Technical Journal

MY 2017 XC90/S90 D-TPMS system changed to I-TPMS

REF NO:
31694

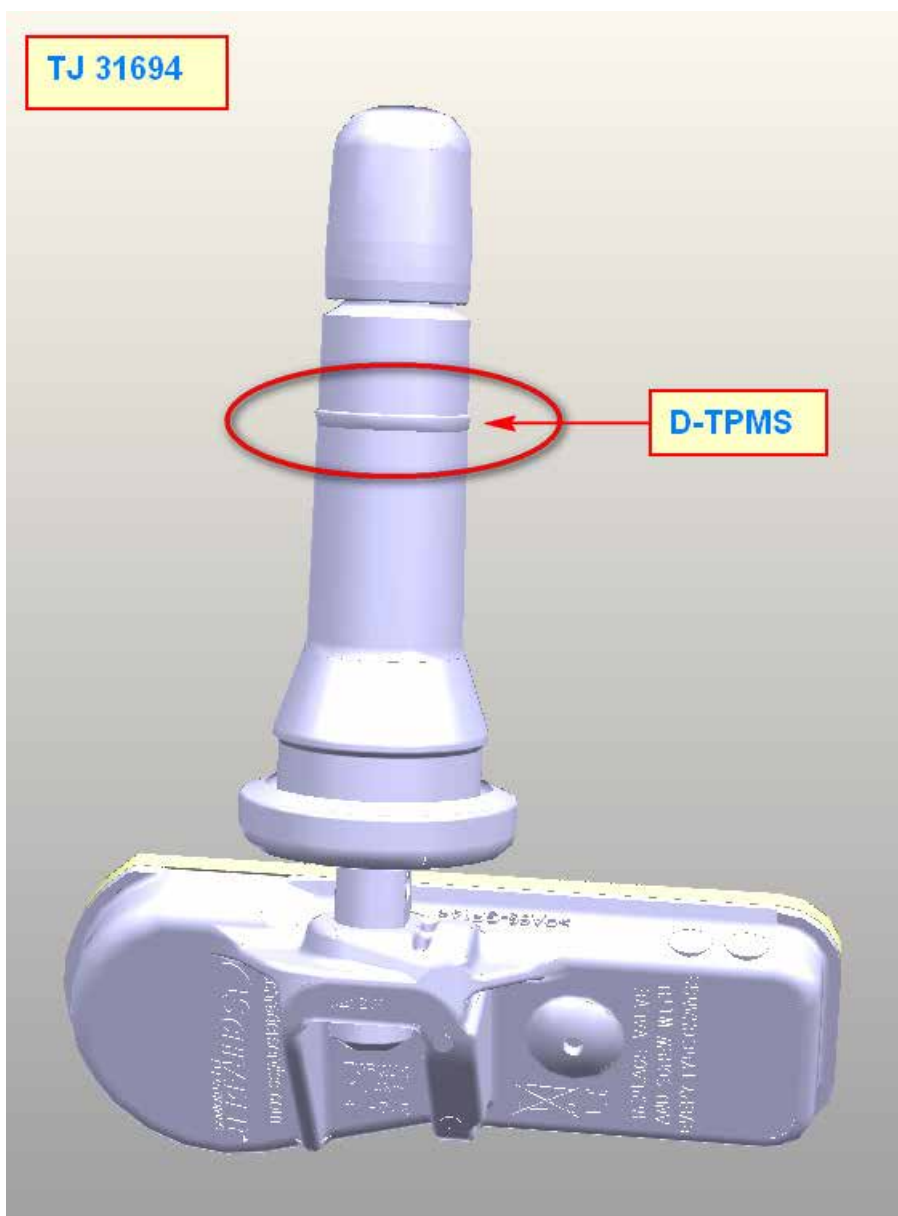
Note: Vehicles with D-TPMS sensors can be identified by the unique tire air valve, it has a “ring” in the rubber, see photo. A normal air valve does not have this ring.
